NEA/RWM/PEER(2012)2

NUCLEAR ENERGY AGENCY  
RADIOACTIVE WASTE MANAGEMENT COMMITTEE

THE POST-CLOSURE RADIOLOGICAL SAFETY CASE FOR A SPENT FUEL REPOSITORY IN  
SWEDEN

An international peer review of the SKB license-application study of March 2011 (Final report)

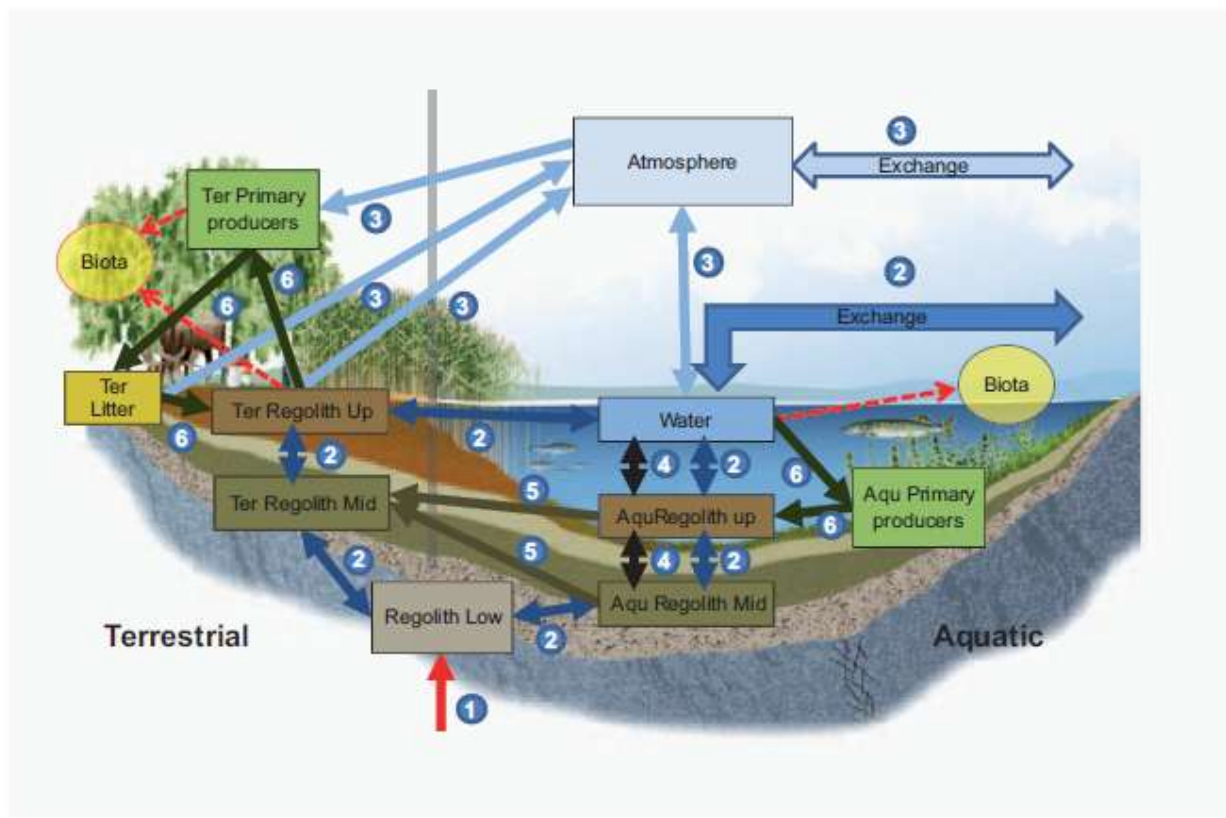
The radionuclide model for the biosphere is a compartment model, where system components that are considered internally homogeneous in their properties are represented by distinct compartments. This is standard practice. The compartment model SKB uses is illustrated in Figure 13-6 in TR-11-01, and is reproduced below. This figure clearly illustrates the various compartments and their connections. The IRT finds SKB's compartments and connections between compartments appropriate.

SKB's assessment of the dose is based on a strong international cooperation in Biosphere assessments. The biosphere analysis for the safety assessment of SR-Site relies upon the application of the IAEA BIOMASS methodology. The exposure of the most exposed group was calculated for a constant release rate of radionuclides to the biosphere, and for a pulse release. Environmental activity concentrations were used to assess the radiological impact on the environment. Only one group is explored (considered as the most exposed group): a family farming wetlands. The justification for this group is its complete self-sufficiency with respect to food and drinking water supply. However, the IRT is of the opinion that some points would benefit from a more precise justification:

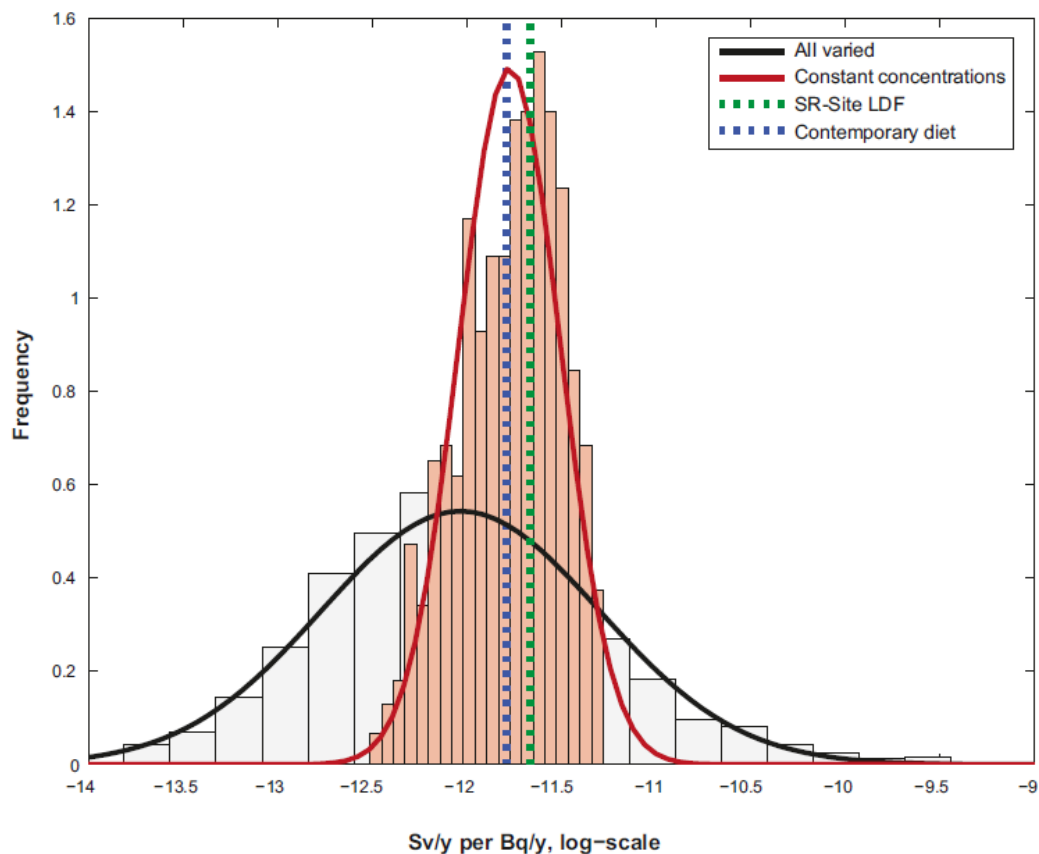
give a reliable estimate of the natural variation. Instead, SKB estimated the  $Kd$  value for Ra-226 from literature data spanning a wide range of geographical conditions and soils types. These seem like reasonable conclusions and approaches.

However, SKB notes that use of literature data “clearly exaggerate the uncertainty of Ra-226 retention at the site”. Thus, SKB decided to use the uncertainty in the Ra-226  $Kd$  estimated from the site data in the probabilistic simulations that addressed the effect of parameter uncertainty. The resulting LDF uncertainty spans several orders of magnitude as shown in the figure below (Figure 12-3 reproduced from TR-10-09). Given the importance of Ra-226 in the SKB assessment, and the lack of site-specific data for  $Kd$  values for Ra-226, the IRT encourages SKB to attempt to provide better site-specific data for future assessments if at all possible. SKB should also consider that such a large uncertainty in the Ra-226 LDFs could mean that better data would result in some other radionuclide or radionuclides dominating the overall dose rate to the most exposed group. This further underscores the usefulness of obtaining additional, site-specific data for Ra-226.

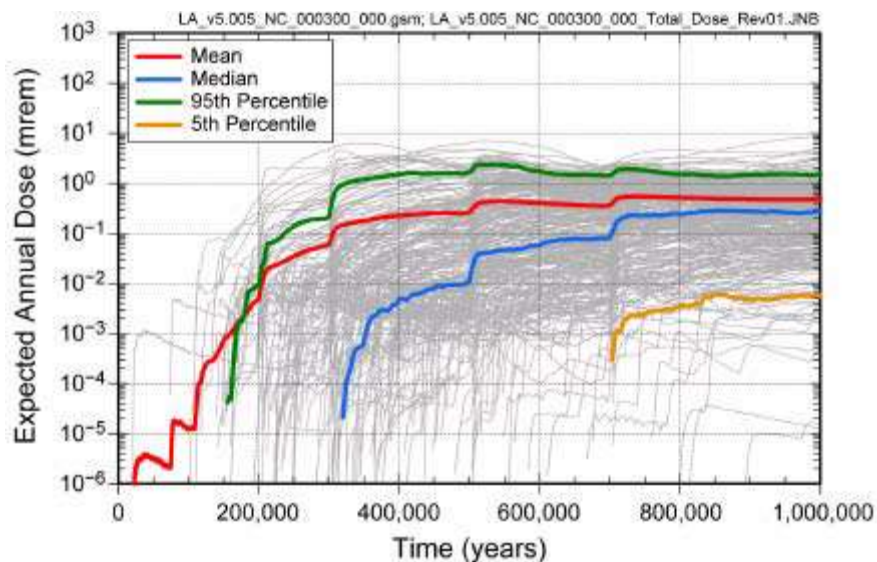
The evaluation of scenarios allows for the calculation of a dose and risk summation, and the conclusions whether the regulatory risk criterion is fulfilled. The risk dilution issue is addressed in a rigorous manner (TR-11-01, chapter 13.9.4): SKB explicitly considers the case of short term releases and calculates an "accumulated short-term risk", following the method suggested in Appendix 1 to SSMFS 2008:37. The result is below the risk limit.

Although the dose calculation based on the technical conclusions drawn from scenarios analyses is sound, the IRT submits the following comment on the presentation of the result: The risk summation curve presents pulse-like features and this is actually an artefact due to the small number of realisations leading to canister failure. Although this does not have any consequence for the demonstration of risk compliance, it is a weakness with respect to the clarity of the demonstration for two reasons:
